Summary of Stakeholder Interviews

MEMORANDUM

RE: *Stakeholder Interviews, Main Street Neighborhood Specific Plan*

Subject: Proposed Alameda Point Conceptual Planning Guide and Zoning Ordinance (Item 7-C on Planning Board's 7-8-13 agenda)

Buildings shown in red have been identified by AAPS & The Alameda Naval Air Museum as the highest priorities for preservation.

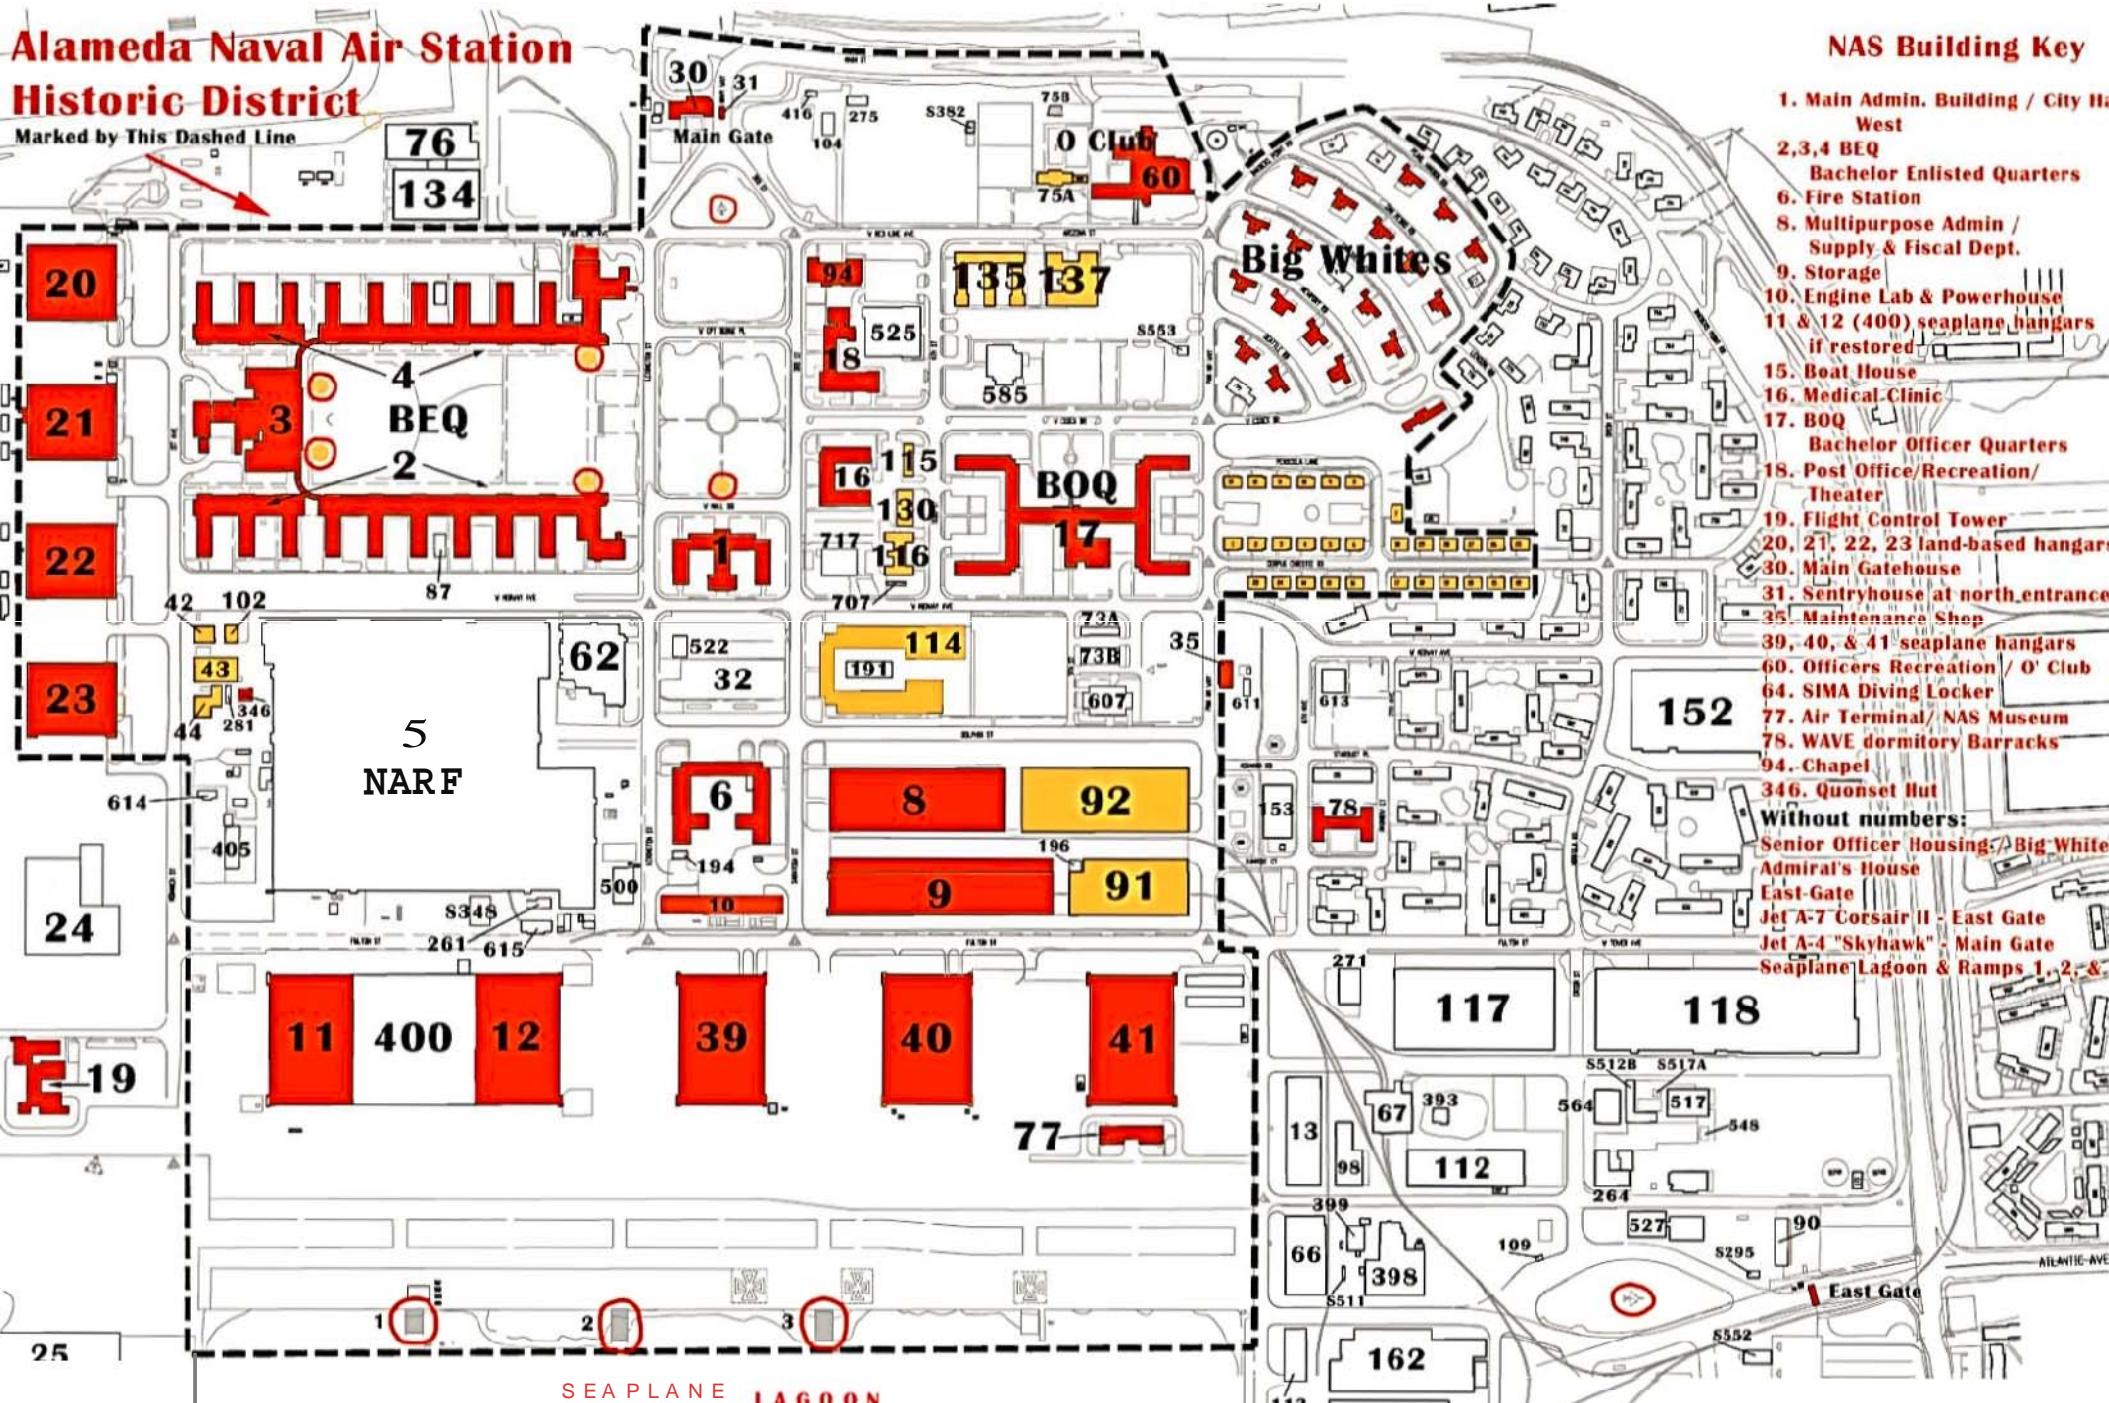
The WAVE Dormitory Building is outside the historic district boundary, but is considered an historic priority by the AAPS (see attached map). WAVE (Women Accepted for Volunteer Service) was the dormitory for enlisted women in WWII. It represents a cultural/historic/social milestone that should be preserved. AAPS would like to see that structure respected.

- *What is AAPS' position in the Bungalows; they are not shown as "priority" structures on AAPS map. Are you in favor of restoration or demolition?*
